Item Name: Baggage Compartment Protector - Floor

DART SERVICE INSTRUCTION

TO AMEND INSTALLATION INSTRUCTIONS IIN-D407-781-2 REV. A OR LATER APPROVED REVISION
AND INSTRUCTIONS FOR CONTINUED AIRWORTHINESS ICA-D407-781 REV. 3 OR LATER REVISION

In some aircraft, the top portion of the D206-781-041 Baggage Compartment Wall Protector Kit cannot be installed as indicated in IIN-D407-781-2. The purpose of this DSI is to provide an alternate mounting method to fasten the top portion of the D206-781-041 Baggage Compartment Wall Protector Kit.

FIGURE 1 - D3879-1 BAGGAGE COMPARTMENT WALL PROTECTOR - ALTERNATE INSTALLATION

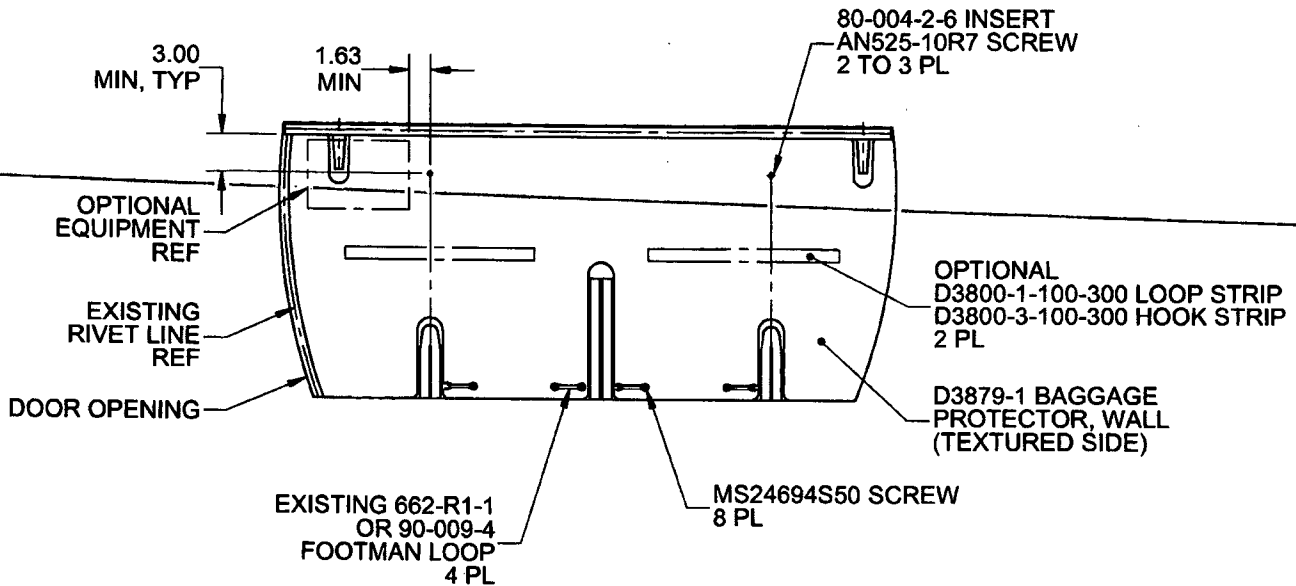
It is acceptable to replace qty(2) D3930-1 Clips with qty(2) 80-004-2-6 Inserts. Locate and mark location of the two attachment holes on the baggage compartment wall as shown in Figure 1 of this service instruction. Install 80-004-2-6 Inserts at the marked locations in accordance with Section 3-2-12 of BHT-206-SRM-1. It is acceptable to trim the wall protectors to accommodate optional equipment or transfer attachment holes to the wall protector and install the optional equipment on top of the wall protector with longer fasteners.

Amend the D206-781-041 Baggage Compartment Wall Protector Kit parts list as follows:

Qty -061	Qty -031	Qty -041	Part Number	Description
X			D206-781-061	BAGGAGE COMPARTMENT PROTECTOR KIT (FLOOR AND WALL)
1	X		D206-781-031	BAGGAGE COMPARTMENT FLOOR PROTECTOR KIT
1		X	D206-781-041	BAGGAGE COMPARTMENT WALL PROTECTOR KIT
		2	AN525-10R7	SCREW
		2	80-004-2-6	INSERT
